Project Reference: *Curcuruto_Minimine 2024-125*
Date: *31st March 2026*

Re: Response to Further Advice

Council Reference	A006805491
Address	42 Minimine Street, Stafford QLD 4053
Lot and Plan	Lots 14, 15 & 16 on RP74335
Proposed Use	Material Change of Use (Multiple Dwellings)

Figure 01- Extract from Council's Further Advice letter

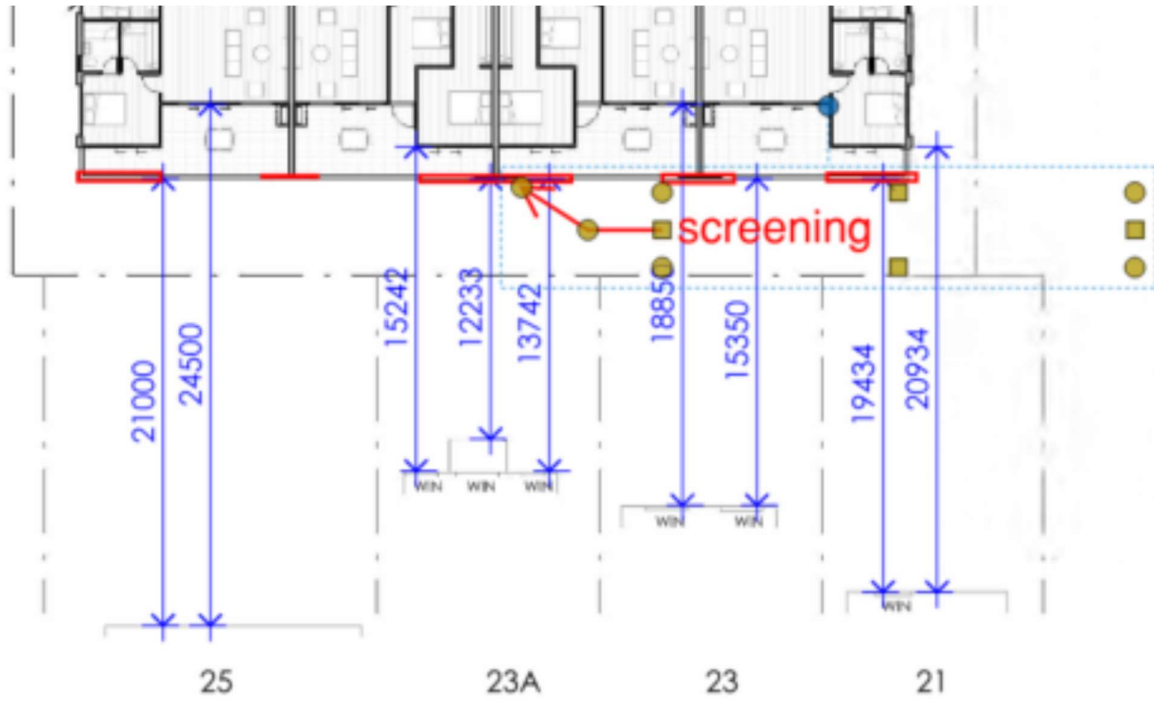
1) It is noted the proposal continues to seek a performance outcome for the rear boundary setback, providing a 4m setback in lieu of the Centre or mixed use code's acceptable 6m. Whilst the plans have been amended to provide obscured glazing for the balustrades, there remains concern that from the rear balconies future residents of the proposal may look directly into the private open space areas of the adjoining low density residential development. Consideration is to be given to incorporating additional screening to the rear elevation to minimise privacy impacts to adjoining development in the Low density residential zone. Some potential locations for additional screening are shown in the plan mark-up below.

Additional screening has been added to the balconies of units facing the rear as per Council's mark-up. Refer to the updated Architectural Plans attached as Appendix A.

Figure 04- Location of exhaust vent

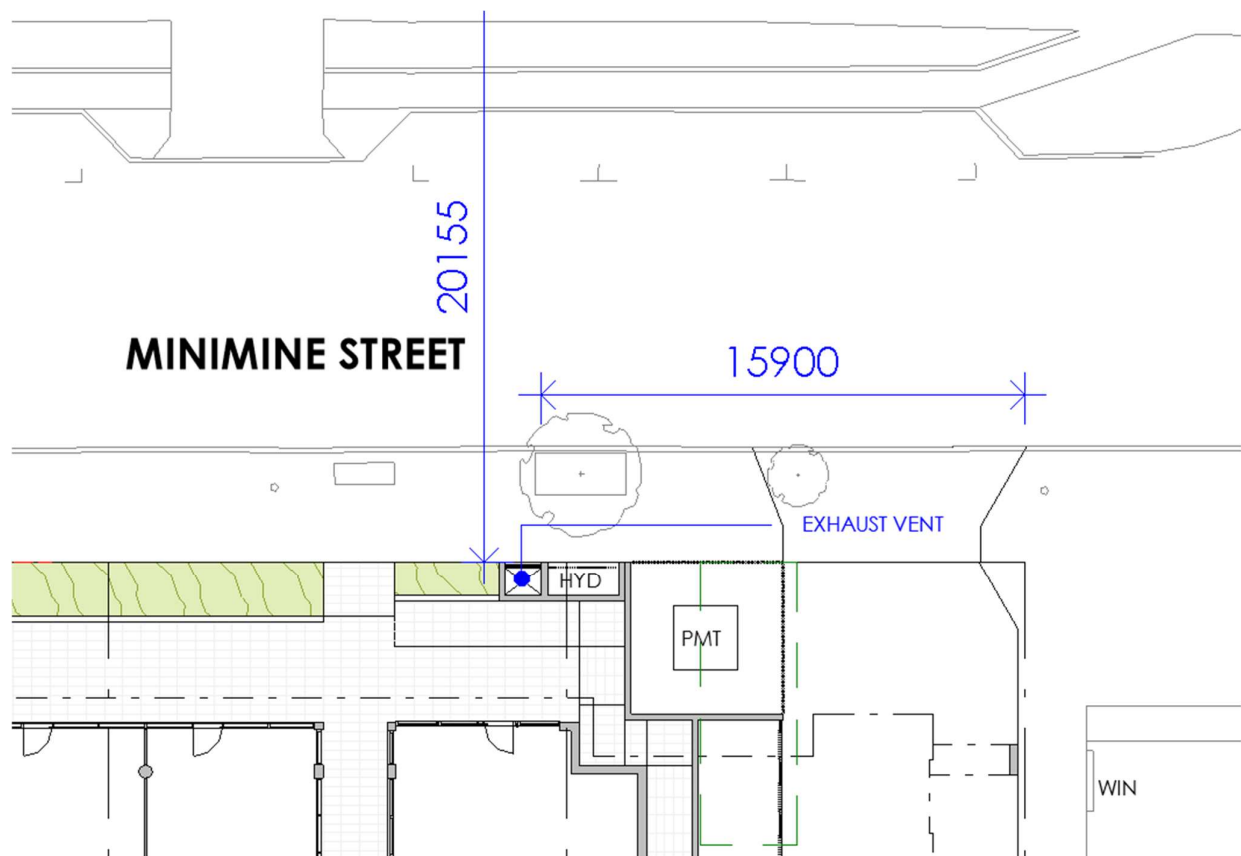
5) It is acknowledged the information request response indicates the basement is partially open, and therefore it can be naturally ventilated and mechanical ventilation exhausts may not be required. It is also noted the response indicates that a condition could be imposed requiring a minimum separation of 15m between exhaust vents from any car park and any sensitive uses, as per AO3.3 of the Centre or mixed use code and AO20.1 of the Multiple dwelling code. This approach relies on future mechanical design for the proposal (including the basement) and does not demonstrate compliance with these acceptable outcomes is achievable.

Given the proposal includes multiple residential levels and adjoins the Low density residential zone, delaying this matter to the Building Application phase of development creates uncertainty, and therefore the ventilation design (including any roof discharge) needs to be considered.

Provide amended plans that indicate locations and design details of mechanical ventilation showing how the minimum 15m between car park exhausts vents and sensitive uses is achieved as per AO3.3 of the Centre or mixed use code and AO20.1 of the Multiple dwelling code.

Where compliance with these acceptable outcomes cannot be achieved by the proposal, provide an air quality impact report in accordance with PO3 and PO20 of the codes, respectively. Guidance on report preparation can be found in the Air quality planning scheme policy.

Architectural plans have been amended to show the exhaust vent setback a minimum 15m from the adjoining sensitive uses. Refer to Appendix A.
